LANDMARKS COMMISSION

AGENDA

1. Call to Order and Pledge of Allegiance
2. Roll Call
3. Approval of Minutes
    - September 29, 2026 [Page 3 – Page 6]
4. Public Comment
5. Scheduled Business
    A. HI-21-25/SP-20-25/RL-09-25, Type III- Quasi-Judicial Process [Page 7 – Page 102]
    Summary: Historic Review of New Construction for a four-story mixed-use building of approximately 27,000 square feet with 37 units, a Site Plan Review for New Construction, and a Replat to consolidate the properties into one lot. The property is located at 300 1st Ave SW.

Historic Review for New Construction, Site Plan Review for New Construction, and Tentative Replat

Sheet C1.3

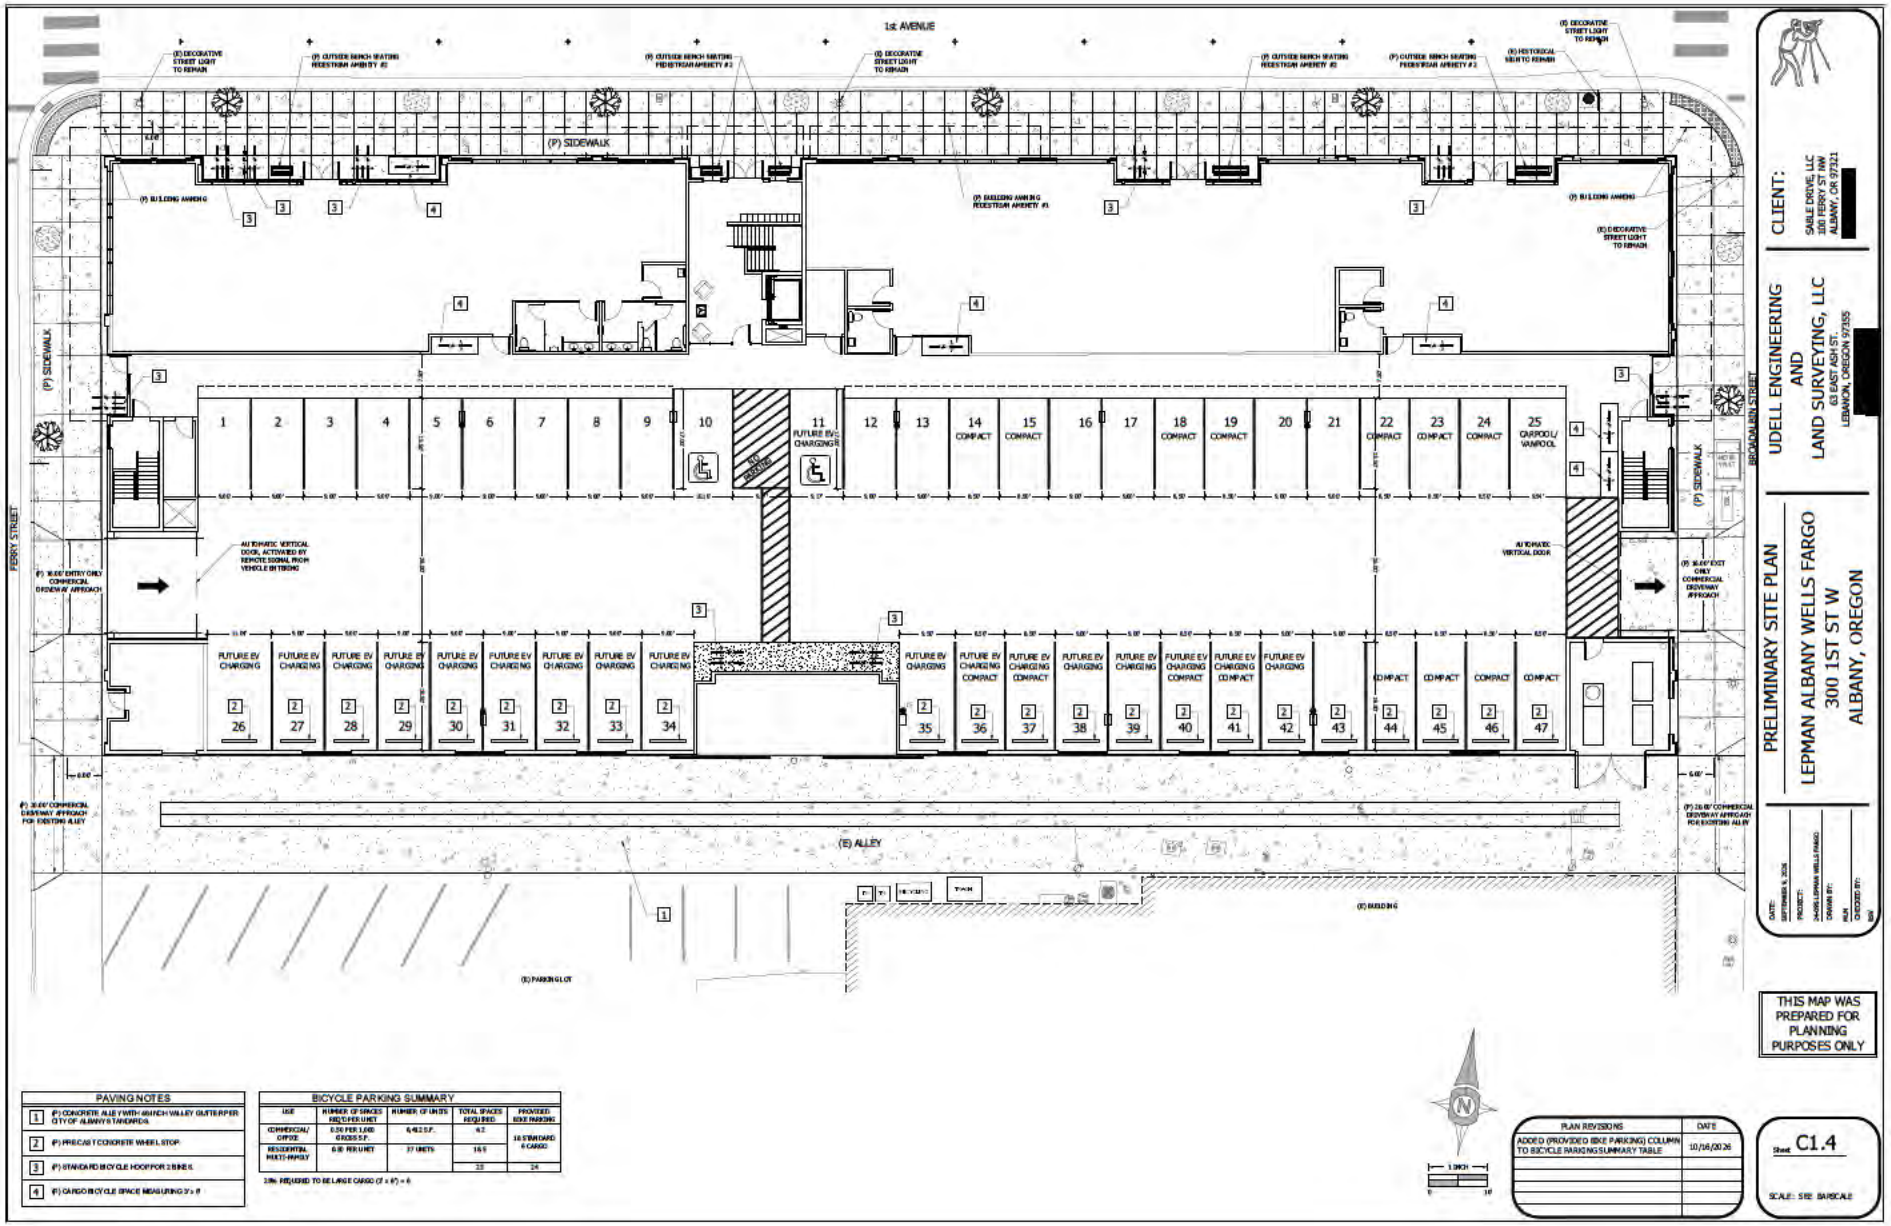
Revised Sheets C1.3 and C1.4 show the revised 26' wide one-way driveway to meet ADC 12.100, including an automatic vertical overhead door system with which the product data information has been provided for review. See Exhibit H for Cookson Door Extreme Microcoil Grille information.

Revised Sheets C1.3 and C1.4 depict the reconfigured parking spaces to allow for adequate backing out and clearance requirements to comply with ADC 9.120.

Revised Sheets C1.3 and C1.4 illustrate the reduced column sizes which provide an increase in the clear width between parking stalls.

Revised Sheets C1.3 and C1.4 note the included alley improvements that comply with current City standards, as referenced in ADC 12.060(2).

Revised Sheets C1.3 and C1.4 show the updated locations of covered bicycle parking near the building entrances, with dimensions that are compliant with Table 9.030-2.

Sheet C1.4

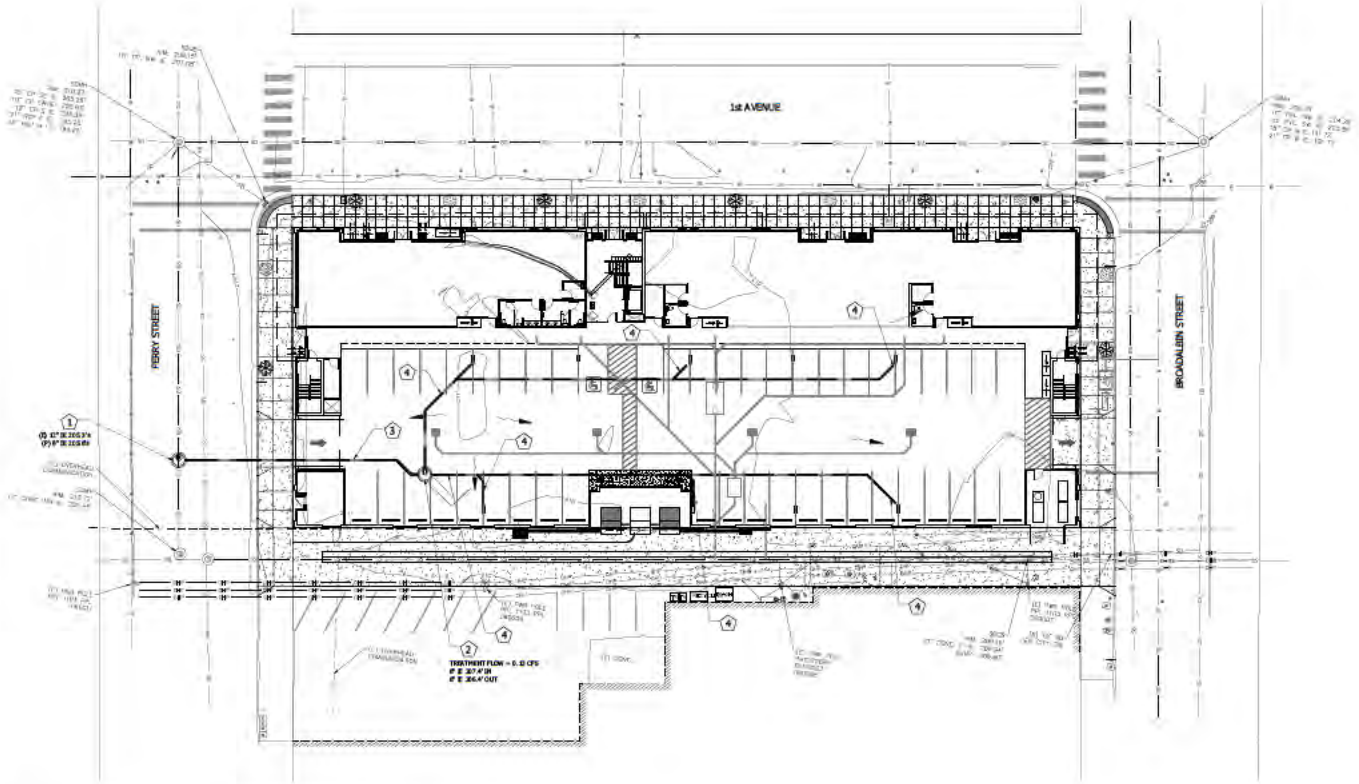
9.8 The applicant provided a site plan showing the removal of access points off 1st Avenue and replacing them with standard curb and gutter. The site plan shows replacement of all the sidewalks along the property frontage with new street trees and reconstructed curb returns. The applicant will remove trees that are partially located within the public alley and existing parking curbing adjacent to the public alley. The applicant proposes to repave the alley with concrete and a valley gutter per Note 1 on Sheet C1.4 and referenced in the applicant's narrative.
